Re: Letter – Addendum  
Response to Review Comments No. 2  
Proposed Catalyst Business Park Buildings 6, 7, 8, and 9  
South of 5750 West and 1500 South  
American Fork, Utah

Roderick Enterprises  
Job No. 1111-029-22  
Letter – Addendum – Response to Review Comments No. 2  
Proposed Catalyst Business Park Buildings 6, 7, 8, and 9  
October 27, 2022

# REFERENCED BORING LOG

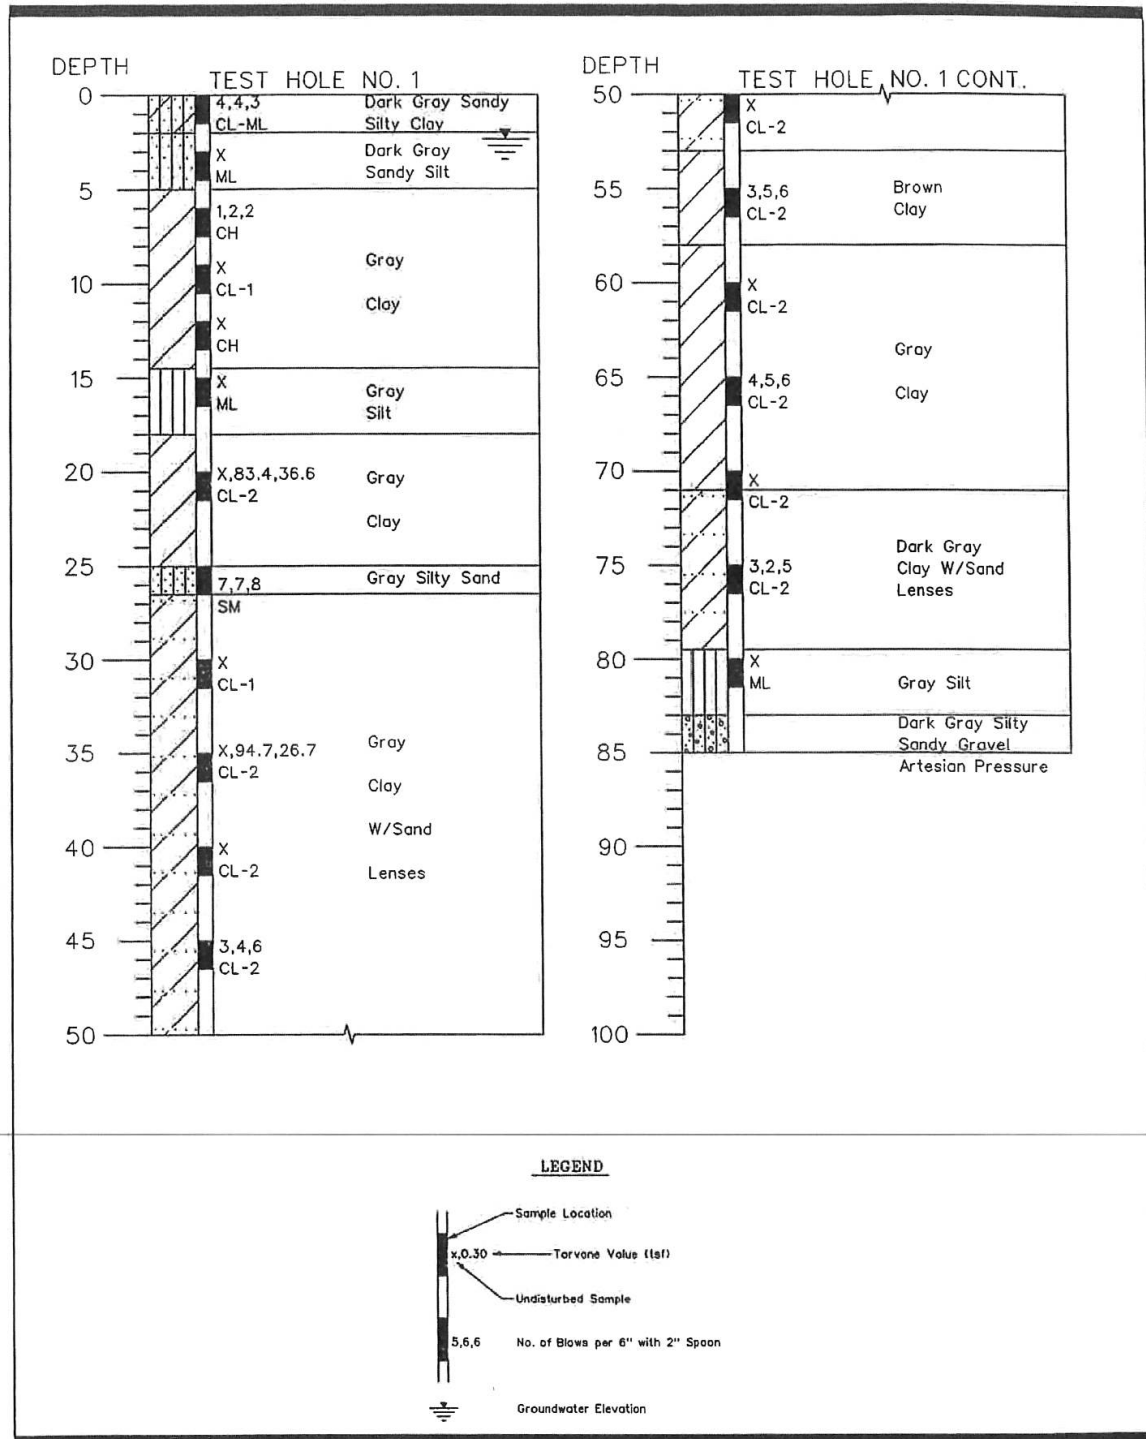
GSH understands that at this time the site-specific response analysis is not accepted by American Fork City's Sensitive Land Ordinance as an alternative to referencing a 70-foot boring for determining site class. GSH was requested to provide the recommended Site Class in accordance with the City Sensitive Land Ordinance by including:

- a) The referenced 70-foot boring shown on a site map;*
- b) The log of the 70-foot boring provided for review; and,*
- c) Substantiation of their respective site class recommendation based on a 30-foot boring at the site and a 70-foot boring.*

The log of the 85-foot Boring completed by RB&G is presented on Figure 2, Referenced Boring Log.

The soils encountered in the 85-foot boring primarily consisted of clay. An approximately 3.5-foot silt layer and an approximately 1.5-foot sand layer were encountered at depths of 14.5 feet and 25.0 feet, respectively. The clay soils below 25 feet were occasionally interbedded with sand lenses. The RB&G study determined a low/moderate liquefaction hazard for the soils encountered within the referenced boring. The soils encountered in the referenced boring were similar to the clay soils encountered during the time of the GSH geotechnical study. However, due to GSH encountering potentially liquifiable soils in Borings B-3 and B-4 the site shall be designated as a Site Class F and a site-specific response analysis is required.
